# COVER SHEET

Mark-up Legend	
Building Review	
Engineering Review	
Fire Review	
Planning Review	
Public Works Review	
Traffic Review	
APPROVED	
BY	CITY OF PUYALLUP DEVELOPMENT ENGINEERING
DATE	
NOTE: THIS APPROVAL IS VOID AFTER 180 DAYS FROM APPROVAL DATE. THE CITY WILL NOT BE RESPONSIBLE FOR ERRORS AND/OR OMISSIONS ON THESE PLANS. FIELD CONDITIONS MAY DICTATE CHANGES TO THESE PLANS AS DETERMINED BY THE DEVELOPMENT ENGINEERING MANAGER.

FOR  
**ARCO ampm PUYALLUP**  
SEC. 33, TWN. 20 N, RGE. 4 E, W.M.  
CITY OF PUYALLUP, PIERCE COUNTY

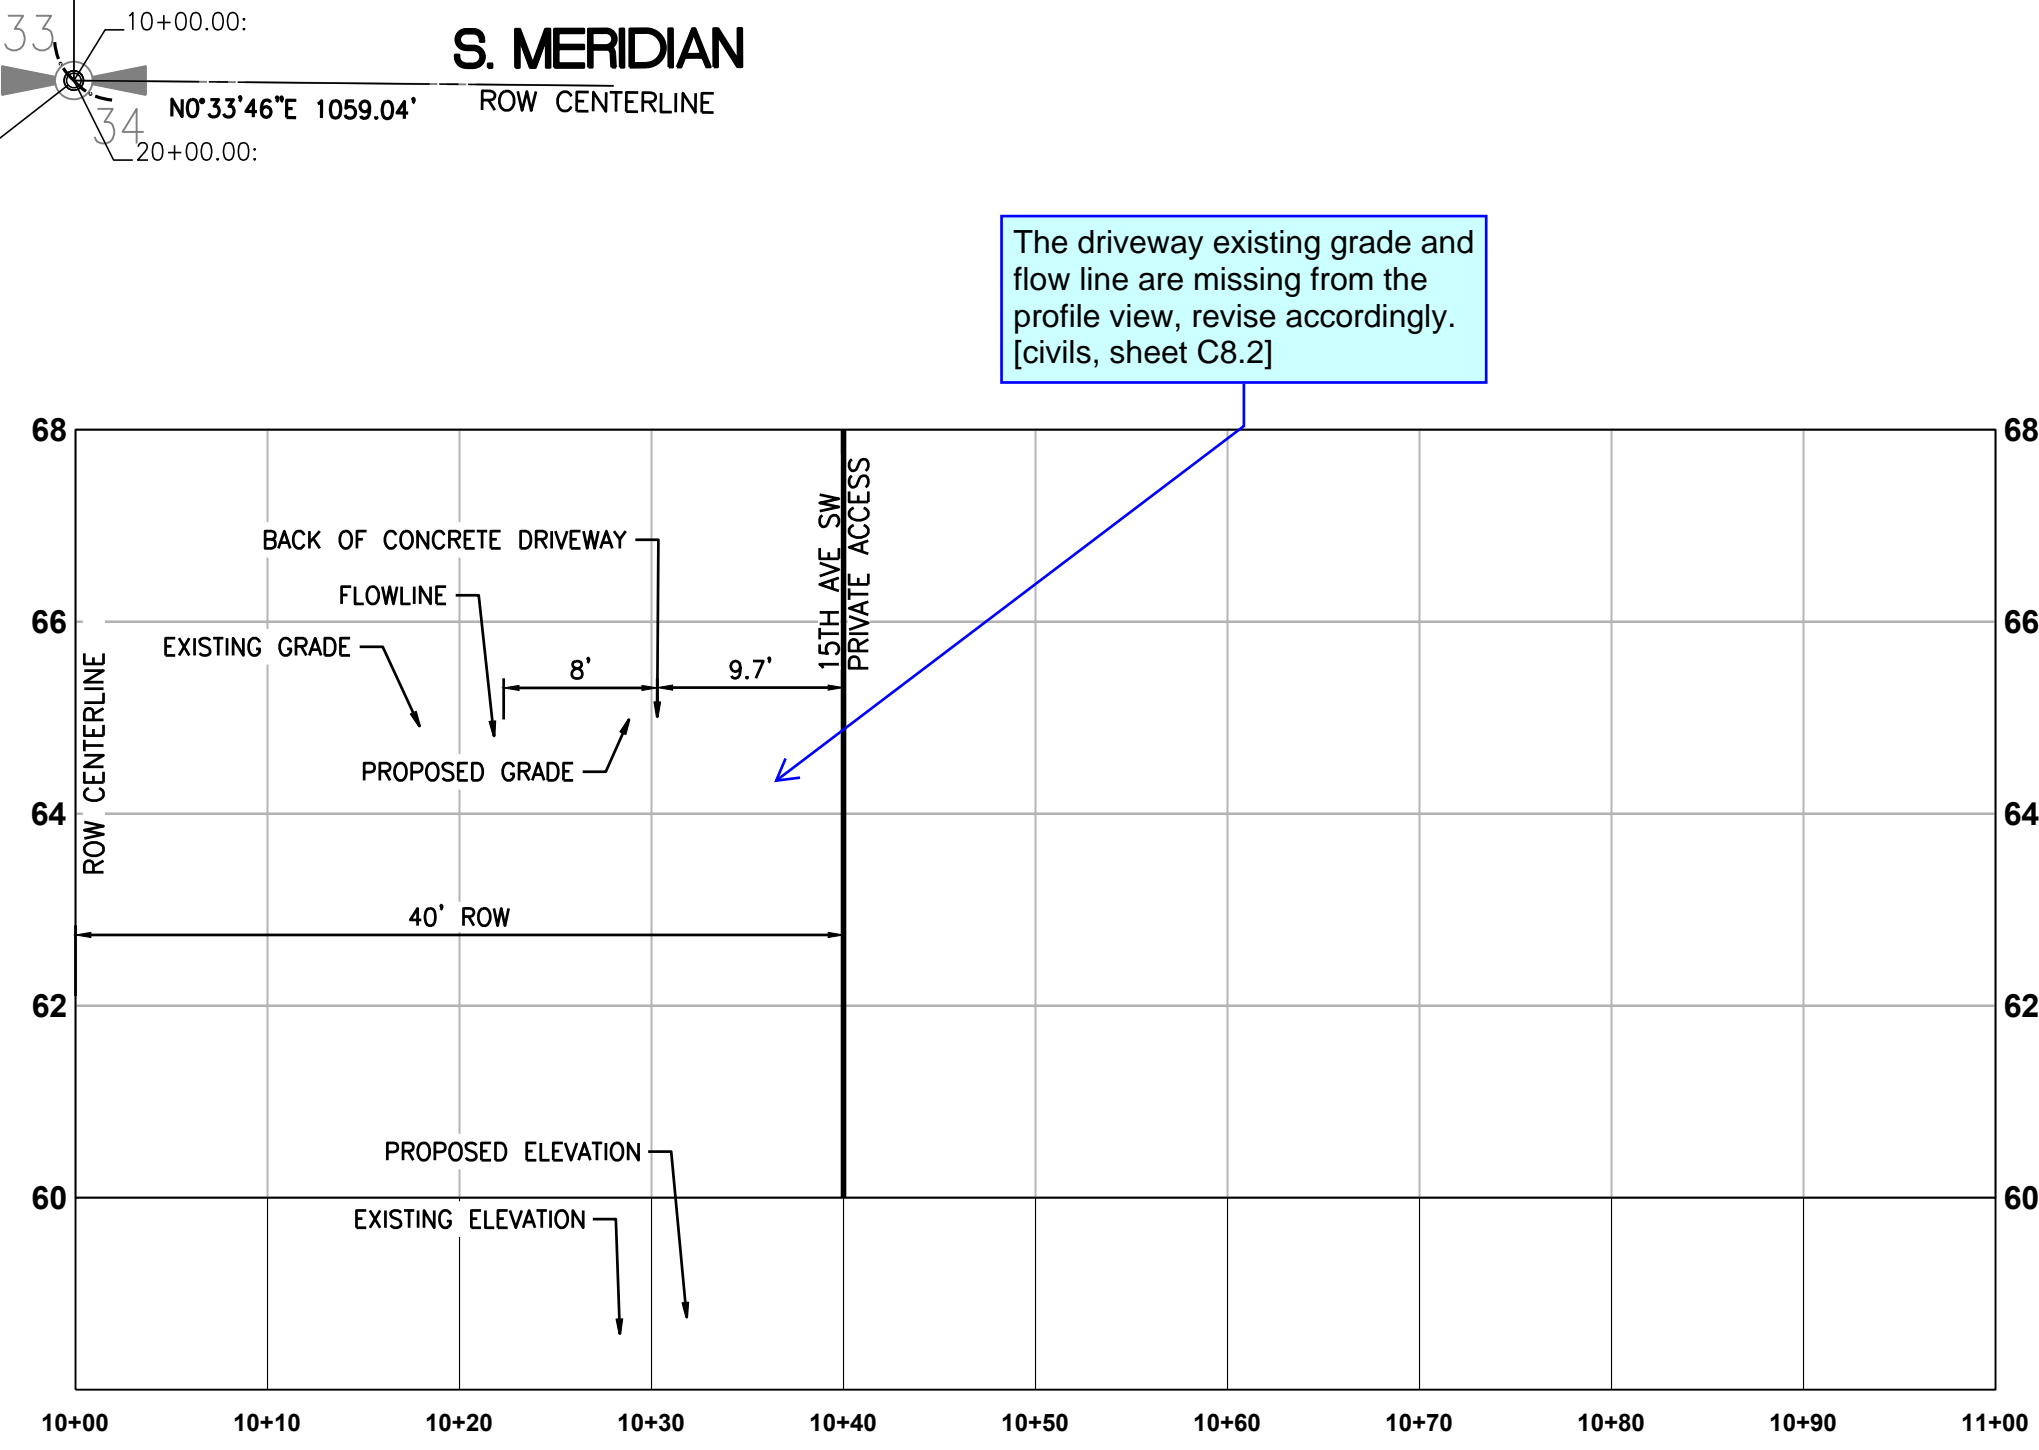
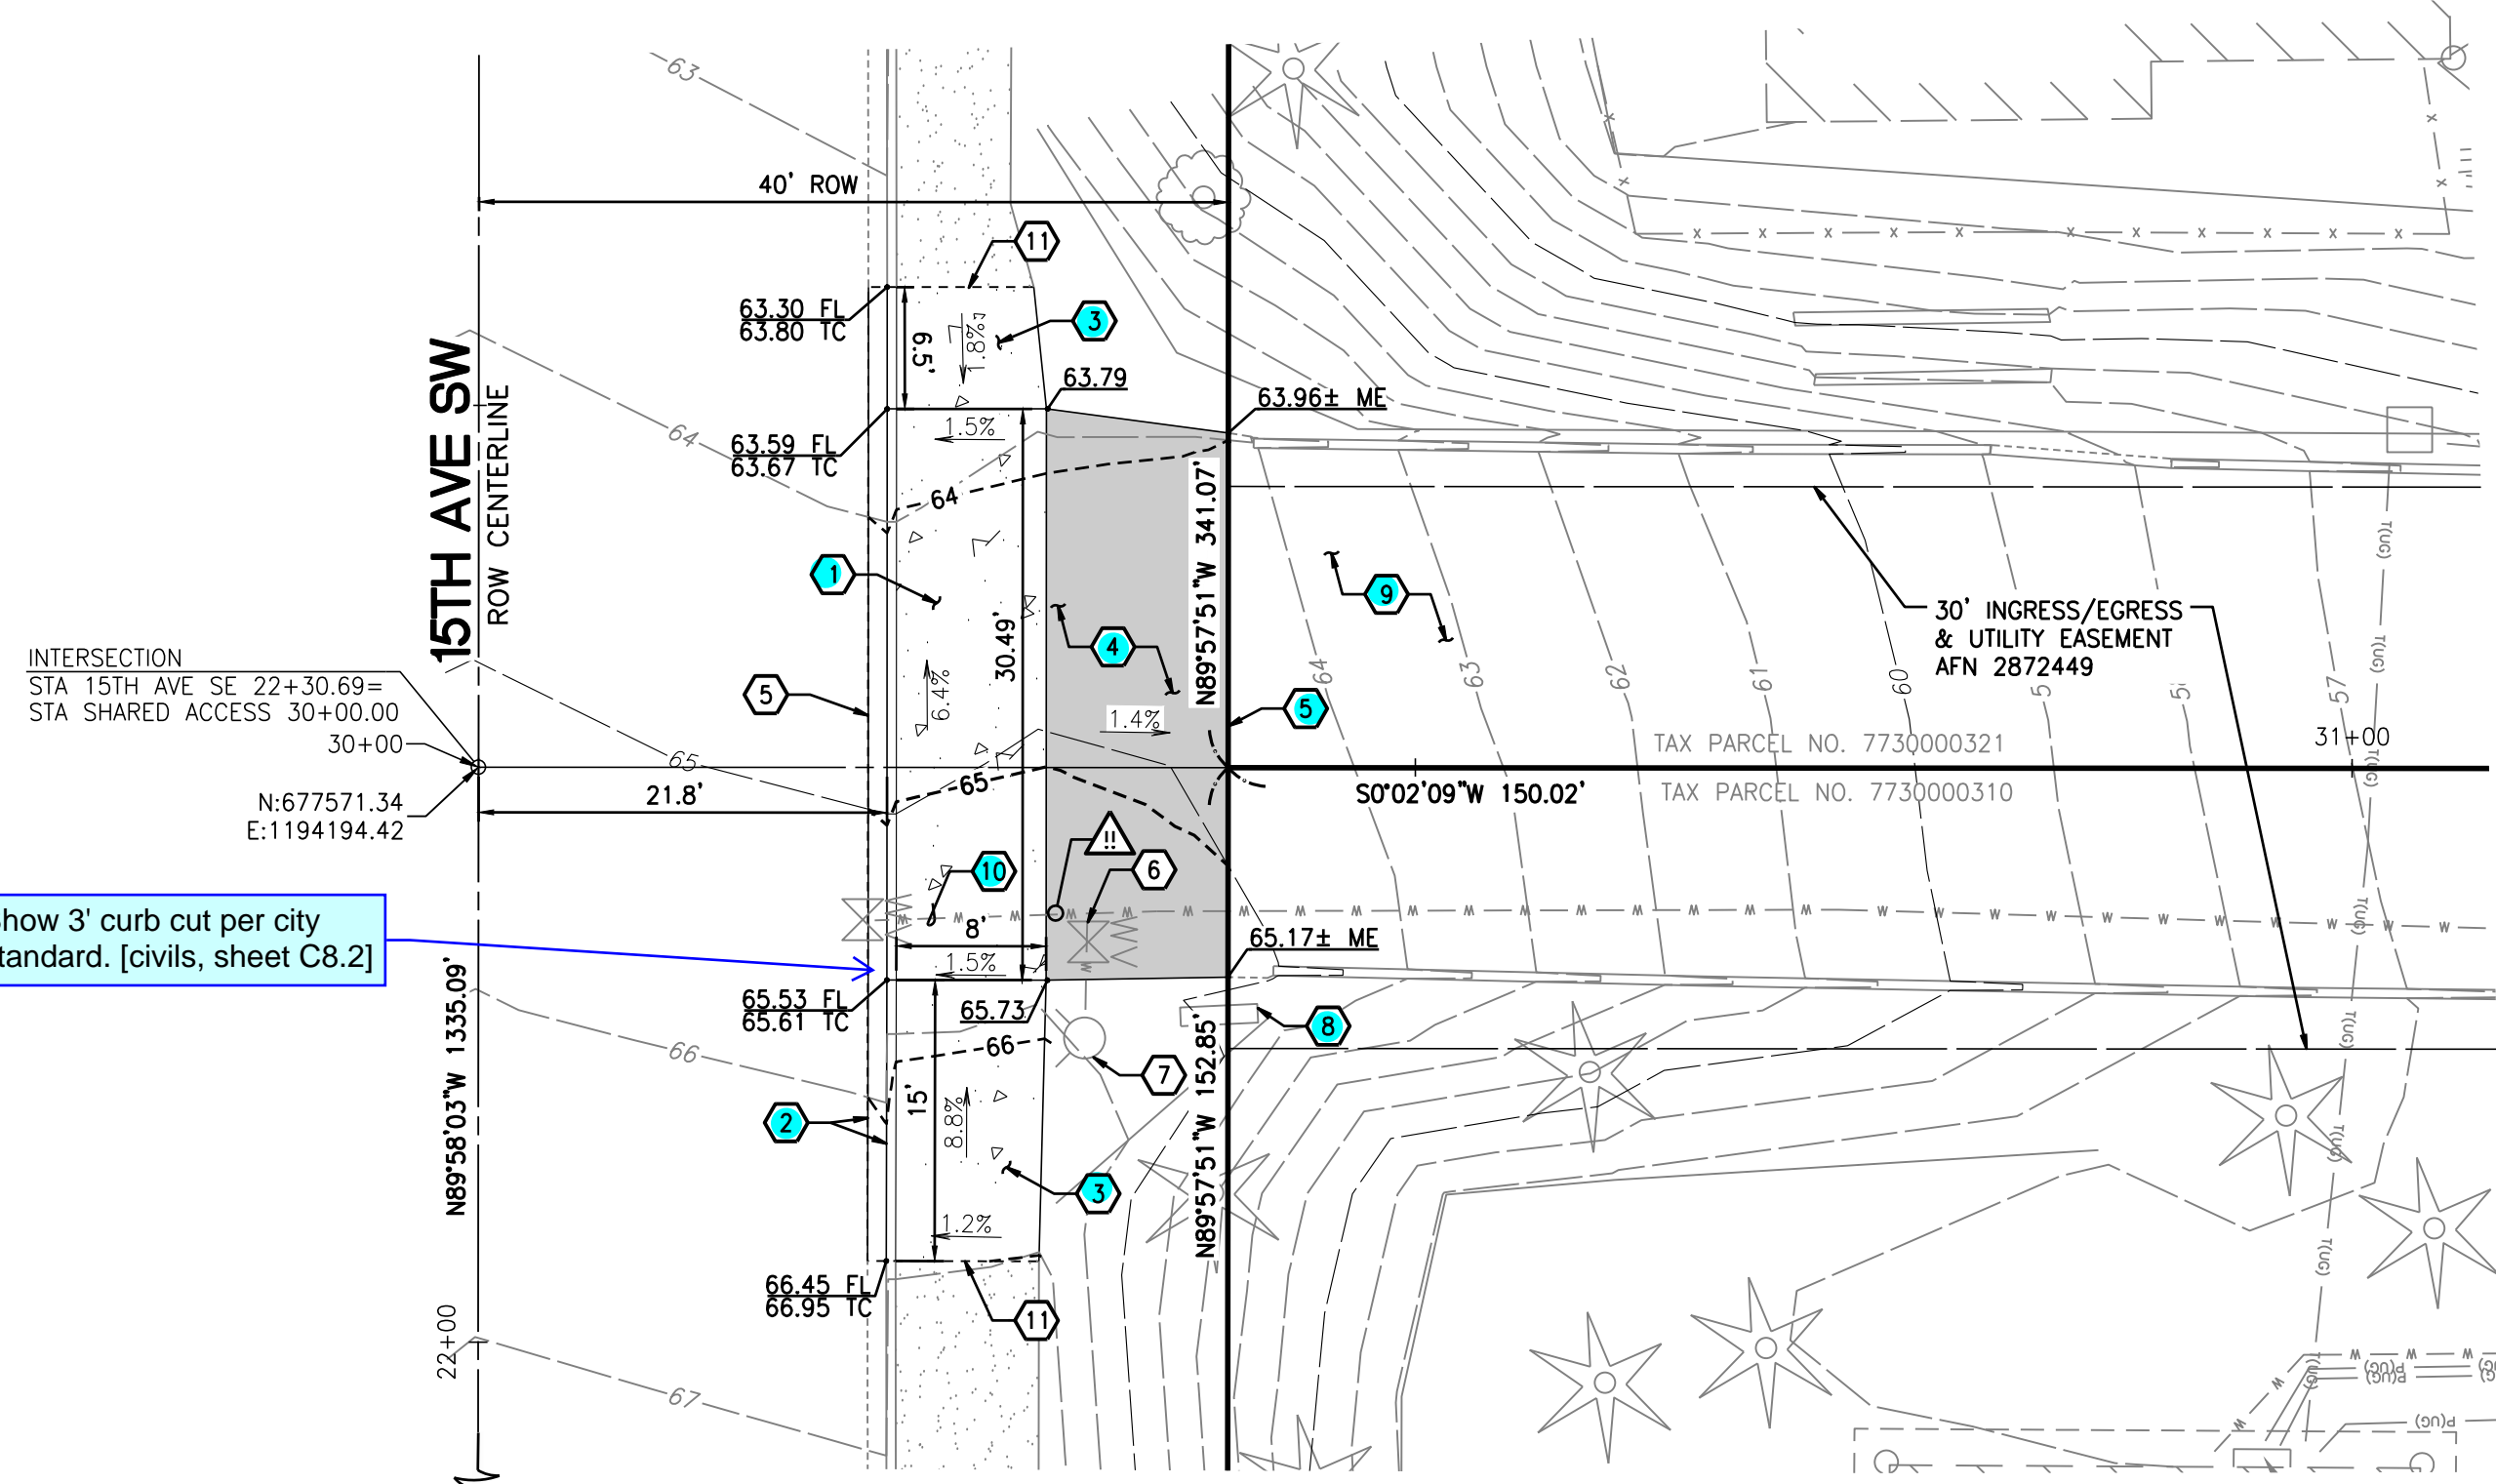
Create a note to have the contractor place a silt sock in the downstream CB to the west of this approach during construction. [civils, sheet C8.2]

Civil Resub Sheet C8.2: This existing fire hydrant has been hit more than once due to turn radius issues with this traffic access entrance/exit. Now traffic on this access road will likely increase 20-fold. Concrete bollards cannot be used to protect the hydrant because they are not crash worthy and would create liability issues for the City. The hydrant needs to be relocated out of the potential large vehicle off tracking turn radius while providing a minimum 3-foot flat clear zone around the hydrant. This fire hydrant is currently placed behind the sidewalk, and it is located too close to the private access driveway that will allow every vehicle coming from northbound S Meridian, as well as any traffic from 15th Ave to access this proposed Arco fuel station / food mart. Just because the fuel tanker trucks that make deliveries to this development will not use this private access driveway does not mean traffic will not increase. Food delivery vehicles for the food mart will likely use this entrance, as well as private vehicles pulling trailers with recreational vehicles that want to fuel up at this development. We have high static water pressure on 15th Ave SW. If the fire hydrant gets hit and breaks the foot of the hydrant below ground, it could potentially take out one of the existing buildings or the access driveway itself, leaving your development without access from northbound S Meridian. If the existing sidewalk is wide enough to allow the fire hydrant to be relocated 15-feet to the east and placed behind the 15th Ave curb per City Standard detail 03.05.01 it should be back far enough to be safe from traffic off-tracking. Having the fire hydrant relocated, would allow the driveway approach radius to be widened and fortified to support the additional vehicle traffic.

If existing asphalt is to remain and be used for forms must be protected and have no concrete residue or staining on road when complete...  
Sheet C8.2 SH

Civil Sheet C8.2: This existing fire hydrant has been hit more than once due to turn radius issues with this traffic access entrance/exit. Now traffic on this access road will likely increase 20-fold. Concrete bollards cannot be used to protect the hydrant because they are not crash worthy and would create liability issues for the City. The hydrant needs to be relocated out of the potential large vehicle off tracking turn radius while providing a minimum 3-foot flat clear zone around the hydrant.
